Sydney Football Stadium

**SSD 9835 Sydney Football Stadium Redevelopment,
Section 4.55 Modification -**

Precinct Village and Car Park (MOD 7):
Design Integrity Assessment Report
(Revision 9, September 2021)

2. Changes to MP1 Car Park East

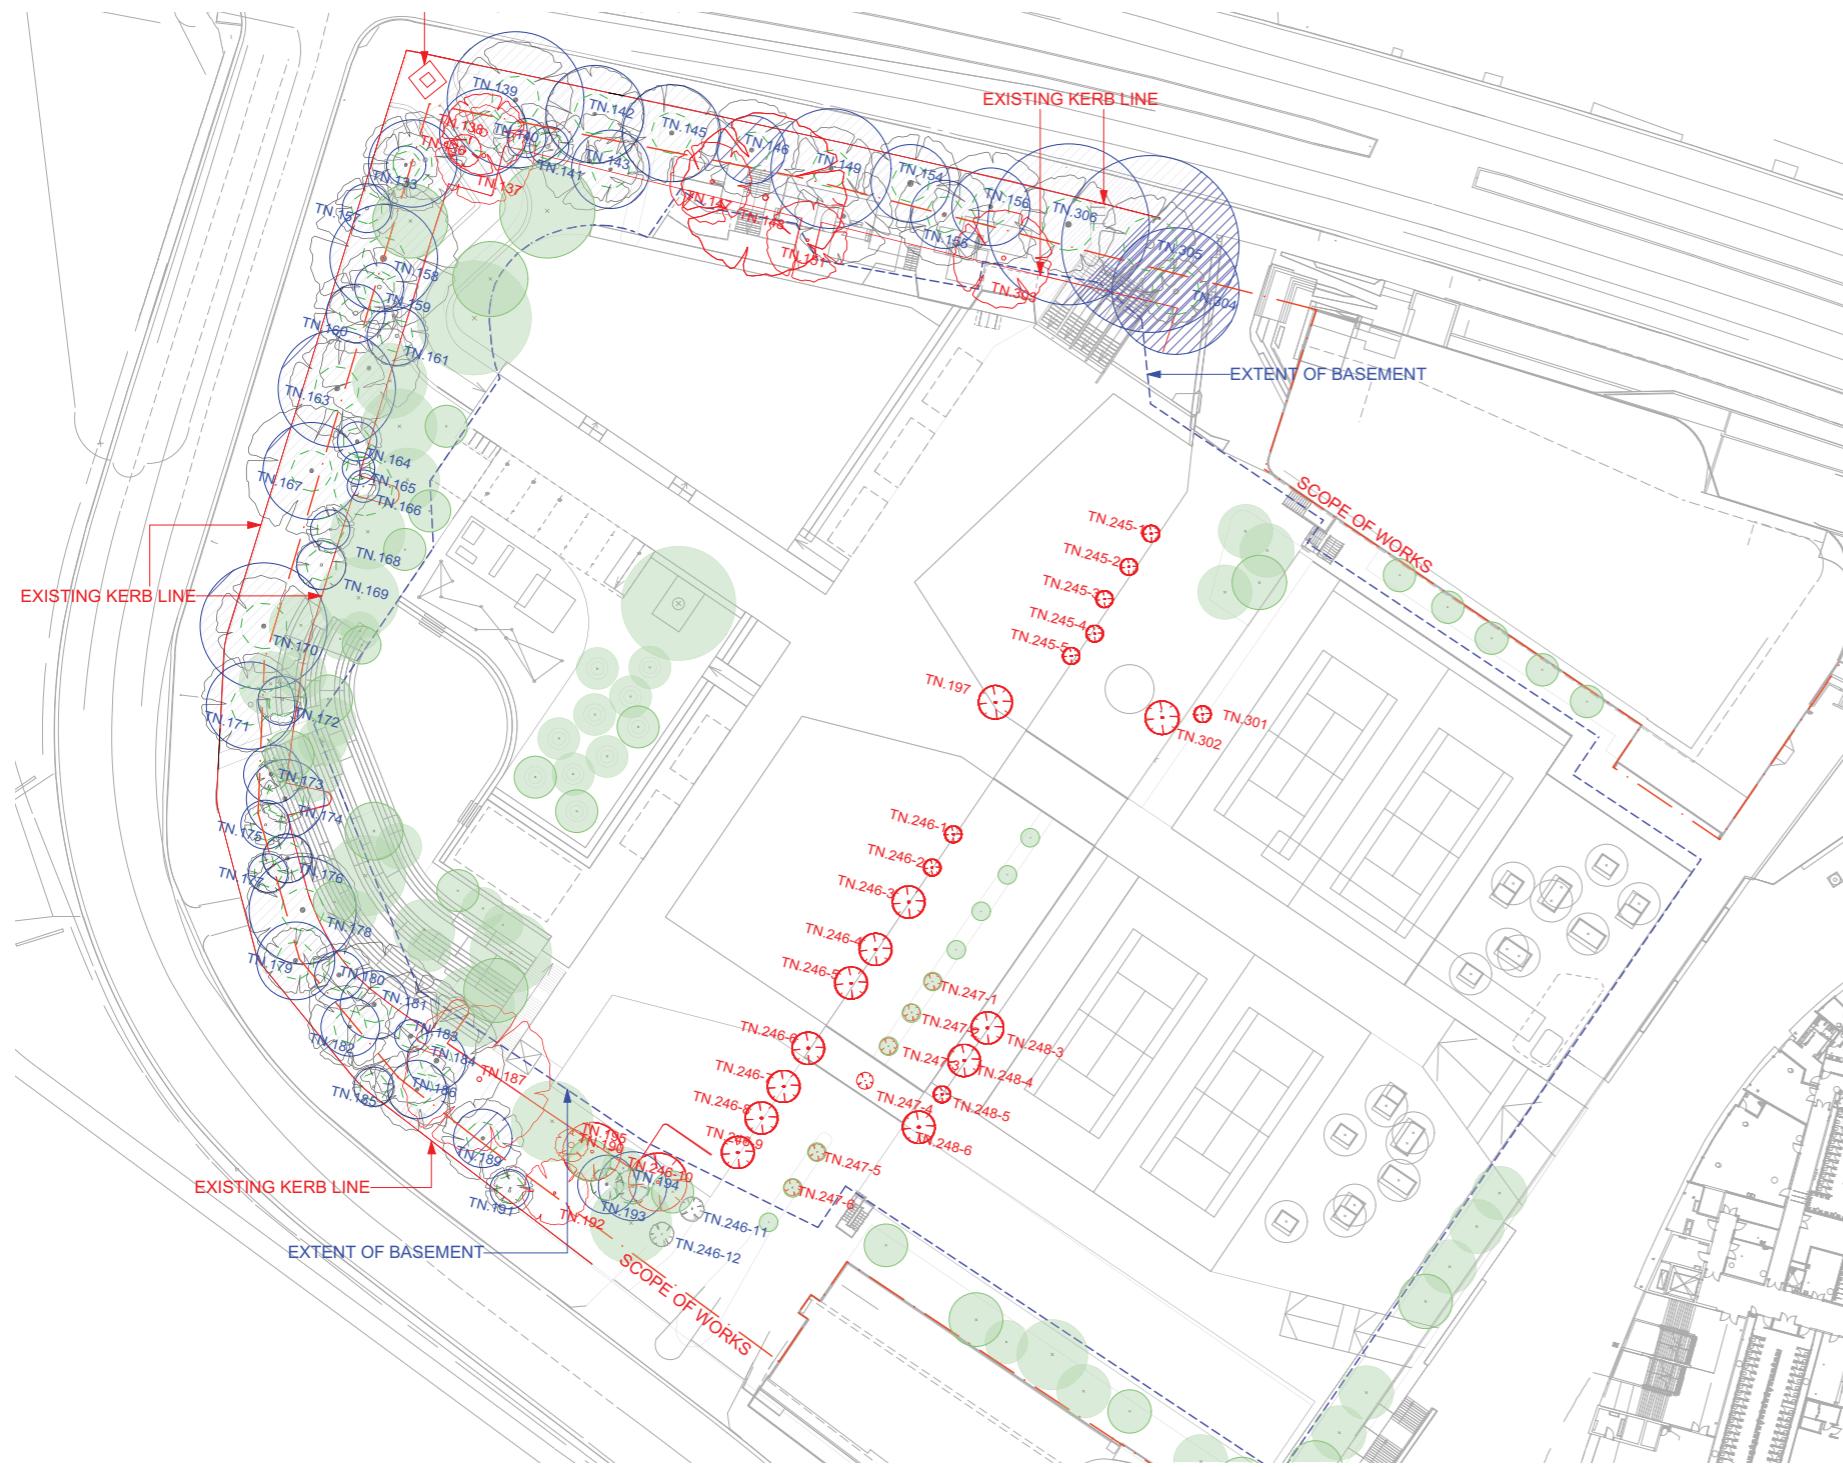
5. The Village Precinct extends the sports amenity offering in the Stadium Precinct with the provision of four tennis courts, a flexible spectator area, pavilion and tennis club house. The spectator area proposes removable seating to provide amenity, comfort and respite in a flexible format that can be customised to suit differing event needs.

By extending the Stadium's concourse feature paving treatment, the area will read as the connector between the Stadium, Stage 2 of the Precinct Village and Moore Park East Parkland. The Tennis courts in Stage 1 have all access 1:14 ramps from the Stadium concourse.

3. Accessible Parking Strategy

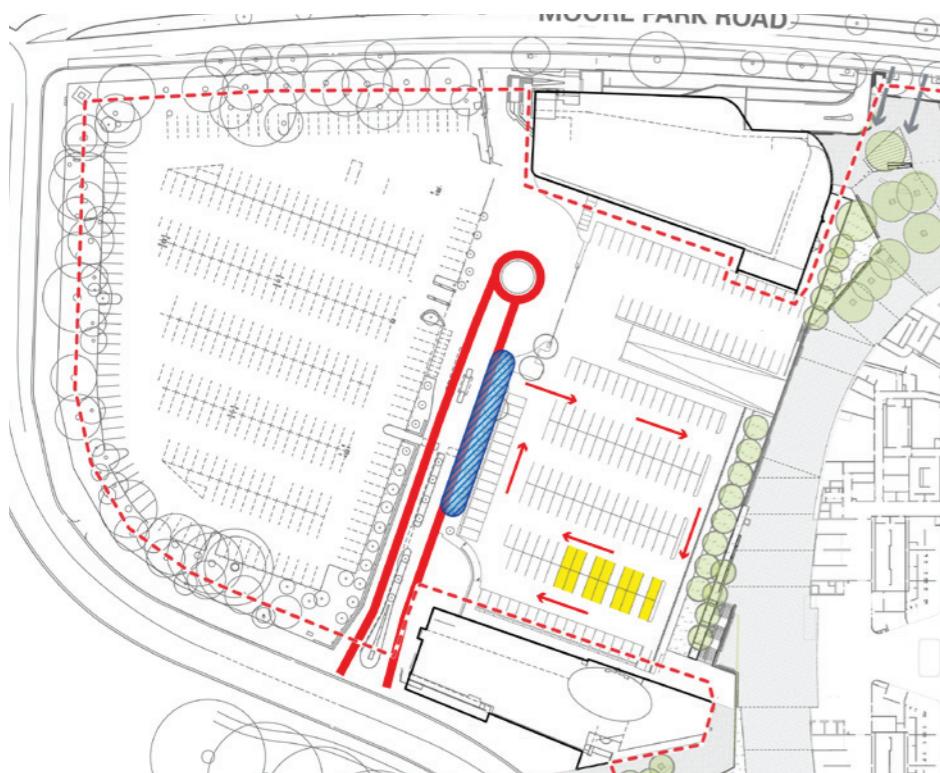
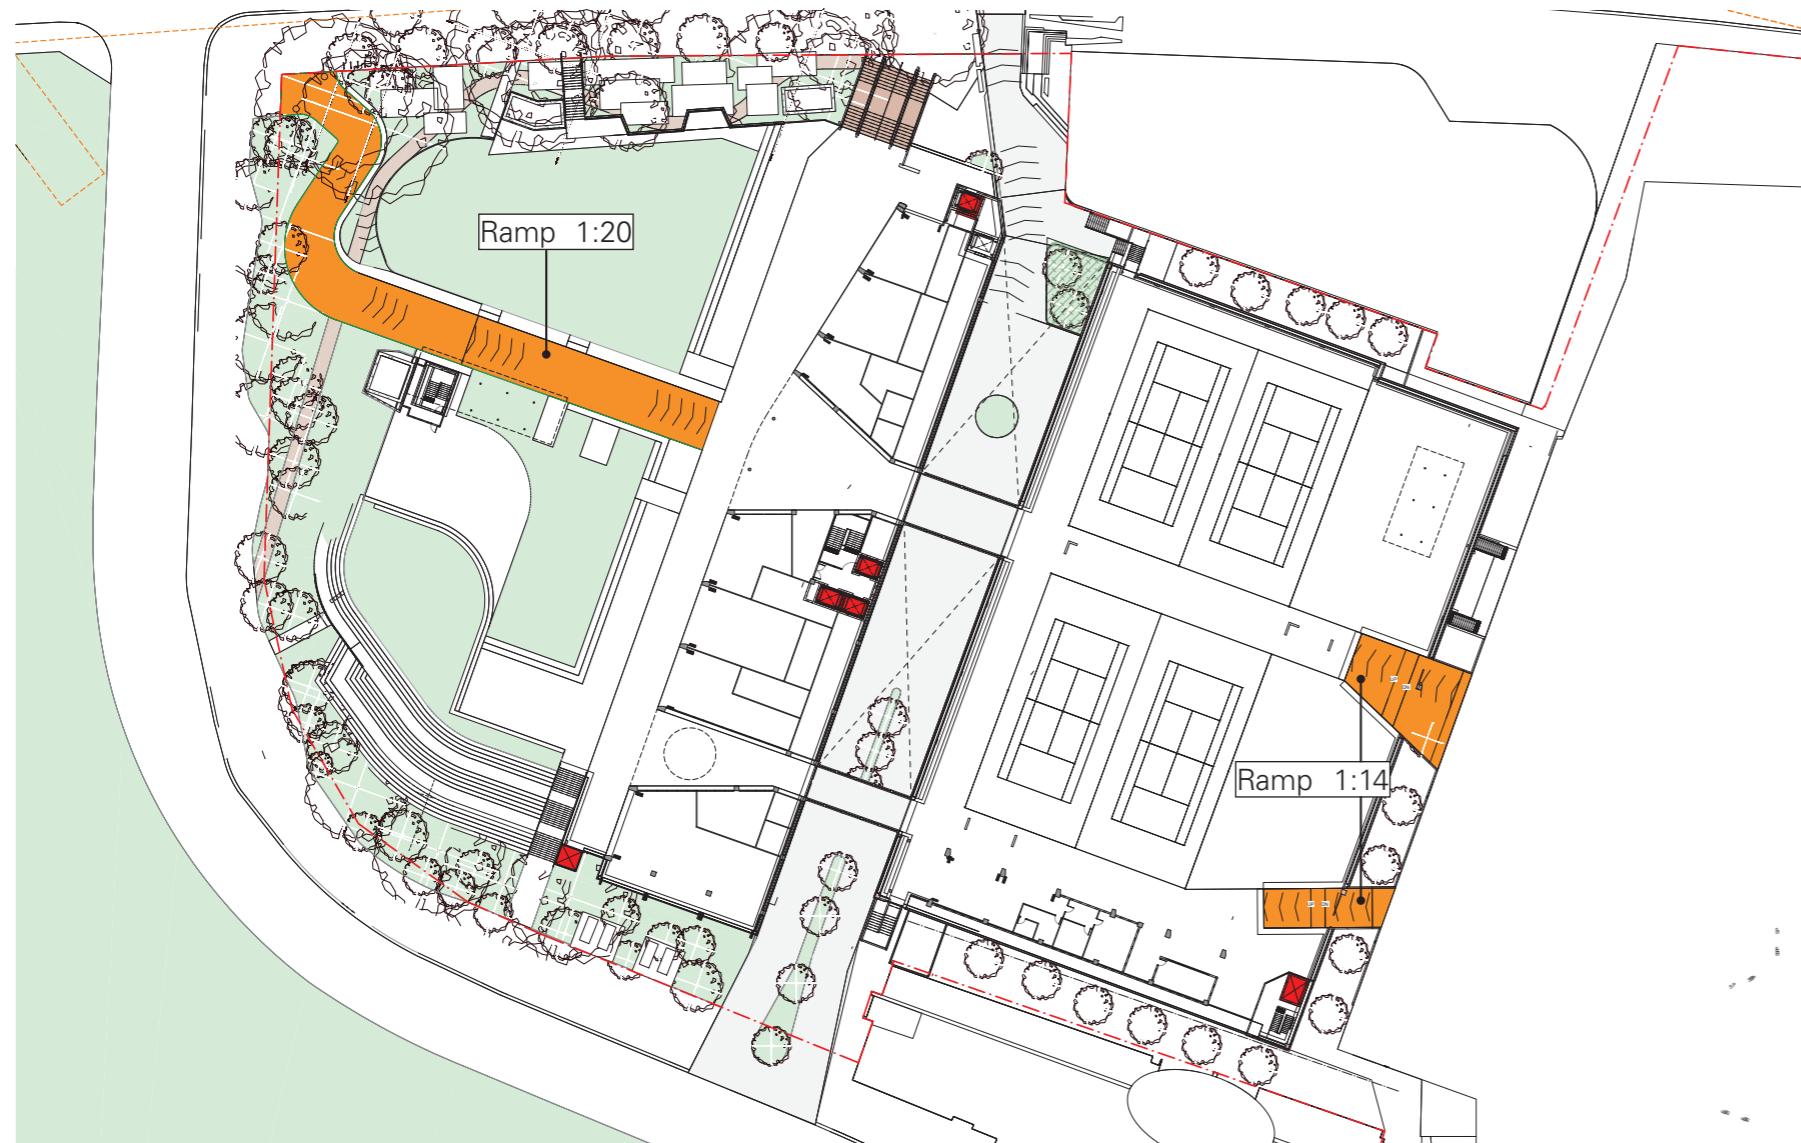
In response to a comment made in the DIP the proposed design promotes universal accessibility, safety and security such that the Village Precinct and Car park is welcoming, inclusive and safe for all users.

Provisions for DDA compliant access and parking within the Precinct Village and Car Park has been incorporated through the following:

- A Persons Requiring Universal Access (PRUA) drop off area has been located within the Precinct Car Park on Level 0.
- Vehicles will enter off Driver Avenue turning right into the East Car Park to circulate to the drop off area.
- The current proposal has retained 11 accessible car parking spaces in the MP1 East Car Park location and allocated a further 24 spaces in the western car park to serve to the Precinct Village.

Plaza Level Plan outlining DDA Access to Precinct Village and Car Park (September, 2021)

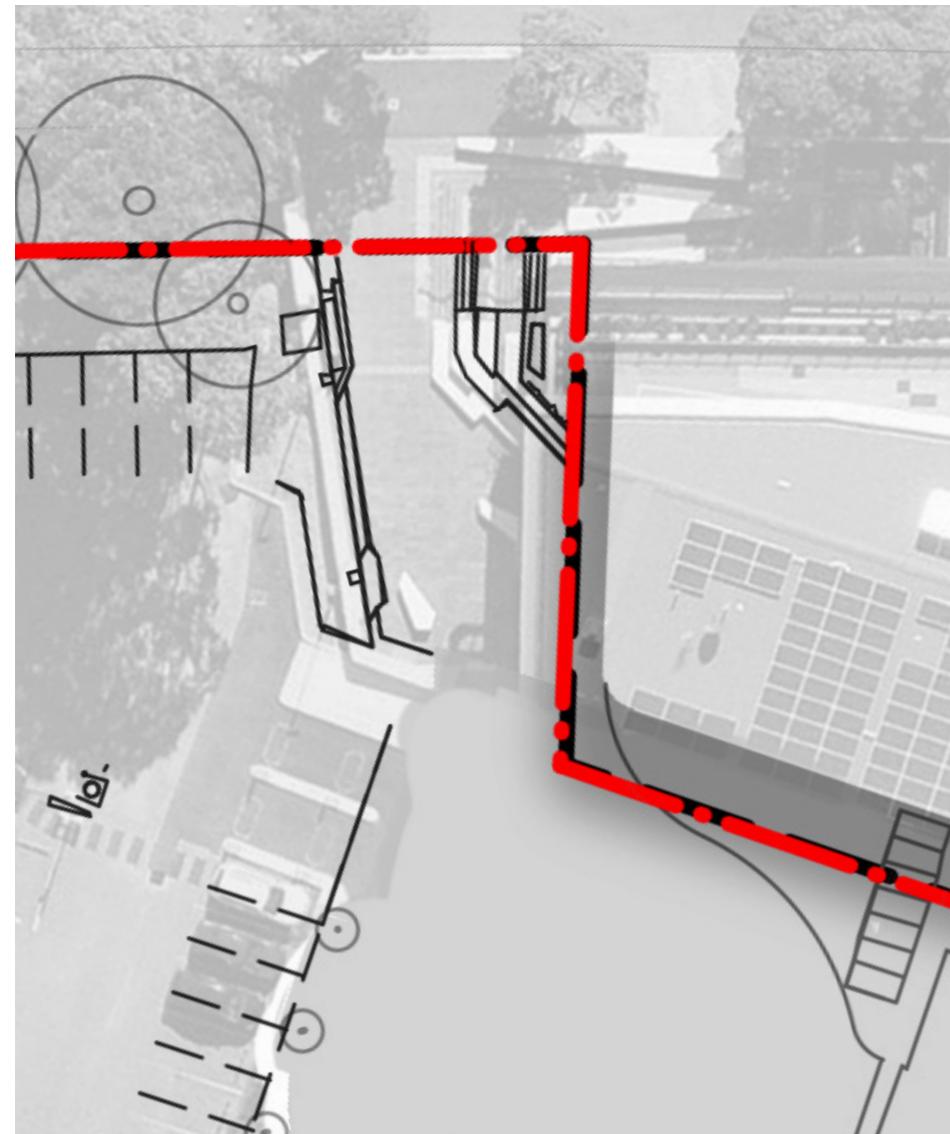
In response to a comment made in the DIP, provisions for a DDA compliant access to and within the site have been incorporated through the following:

- PRUA patrons have compliant access from the drop off area to lifts located within the Level 0 Car Park with direct access to the Precinct Village Plaza level. Six accessible lifts have been provided.
- Compliant circulation paths are provided throughout the Precinct Plaza level with areas to stop and rest to ensure the site remains accessible for those with impairments.
- There are three compliant entry access ramps into the Precinct Village. The pathway entering from the corner of Driver Avenue and Moore Park Road is 1:20. The two access ramps leading onto the Stadium concourse from the tennis courts are 1:14.

5. Roadway width through the UTS Precinct

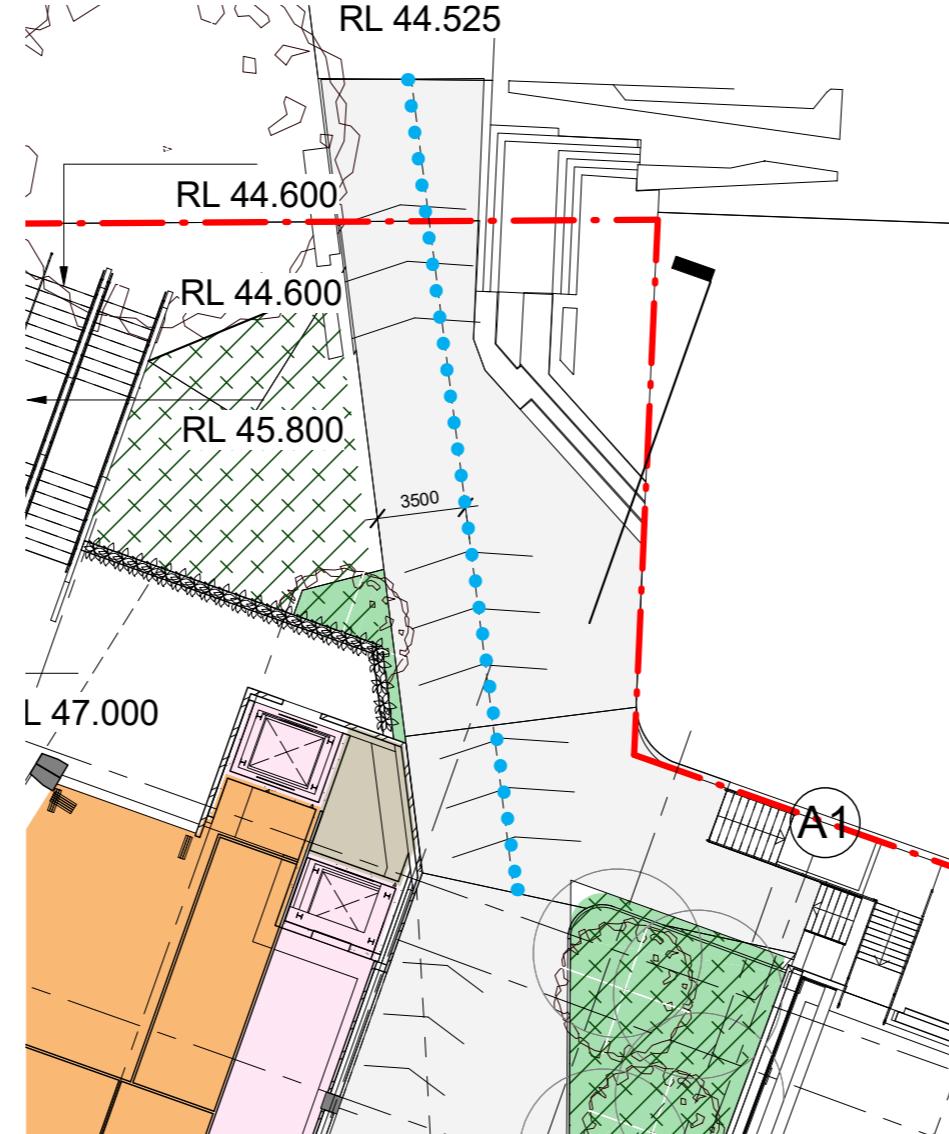
The roadway width adjacent to the UTS Rugby Australia Building is approximately 3.5m. This egress will only be used to cater for additional egress of vehicles out of the car park on major event days. At all other times pedestrians take precedent within this Precinct.

6. Removing Car Parking from Moore Park East

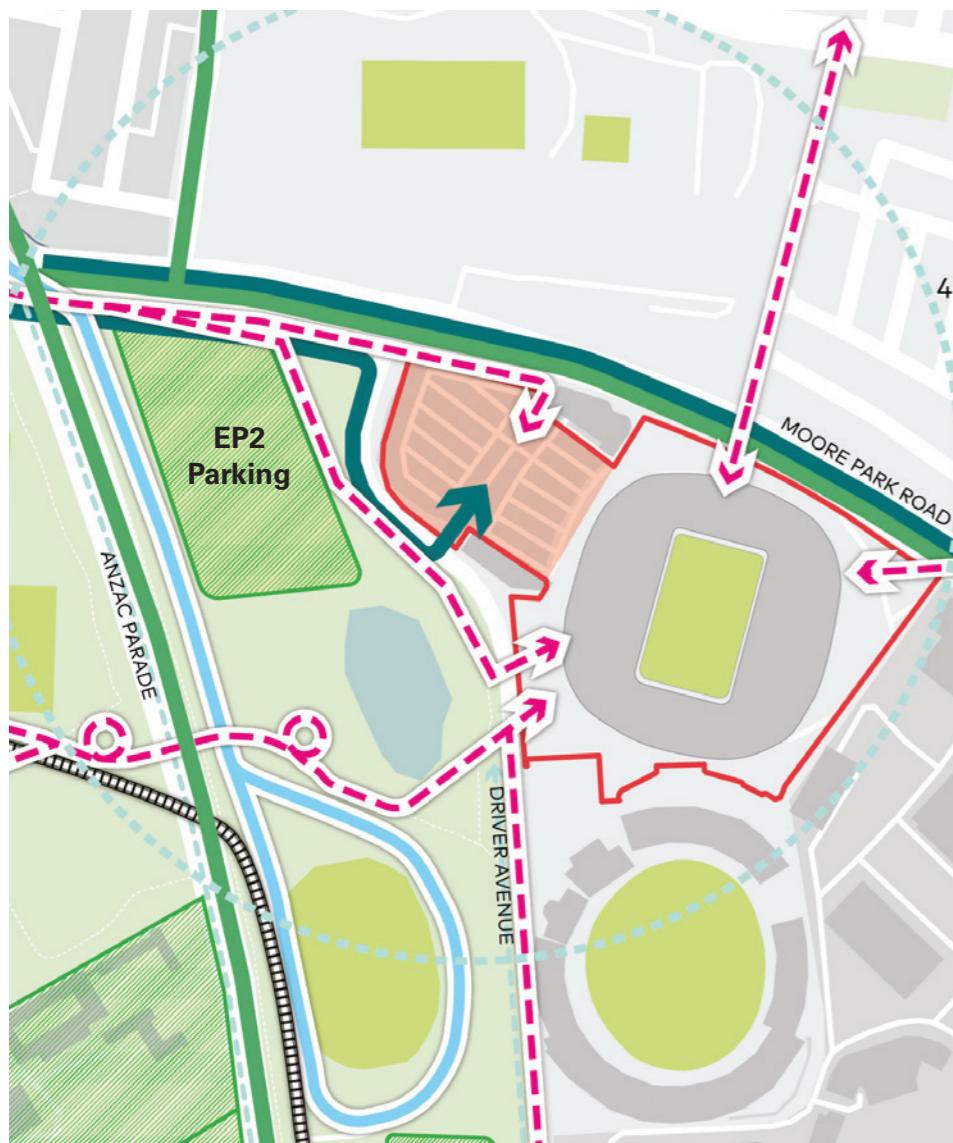
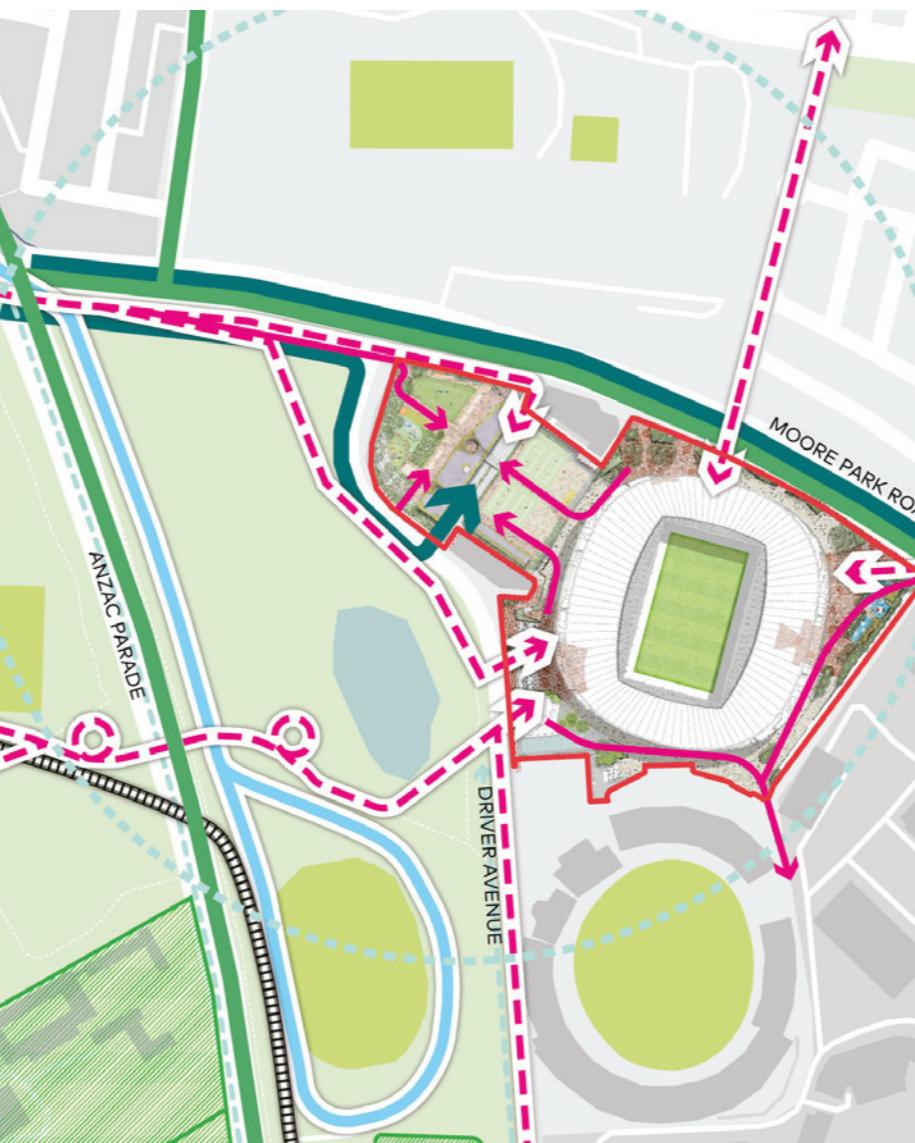
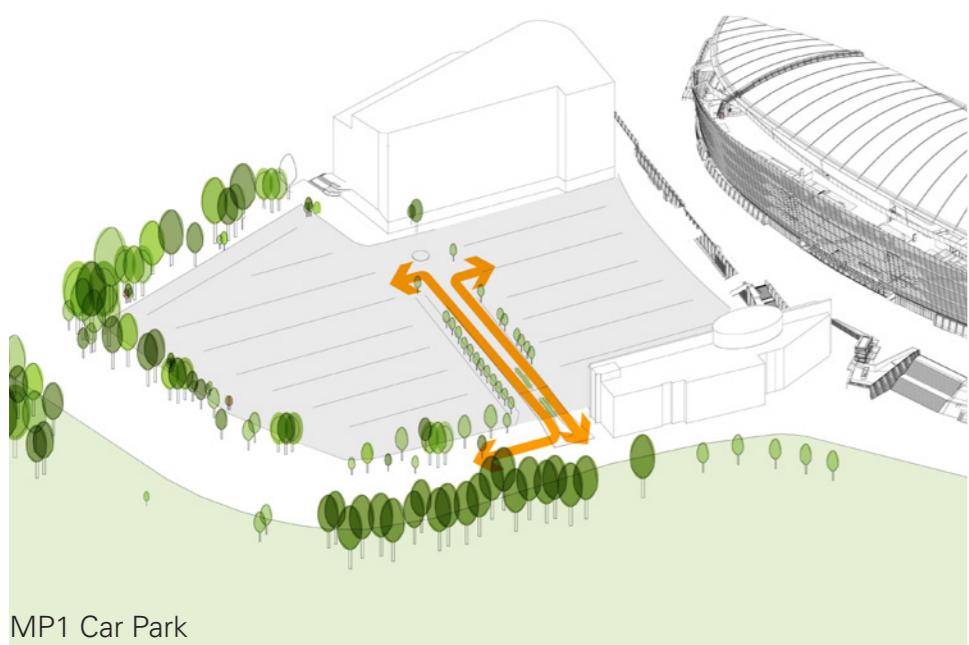
The Precinct Village Car Park design allows for the removal of parking from the Moore Park East Parklands (EP2) because these cars are relocated to the new Car Park on MP1.
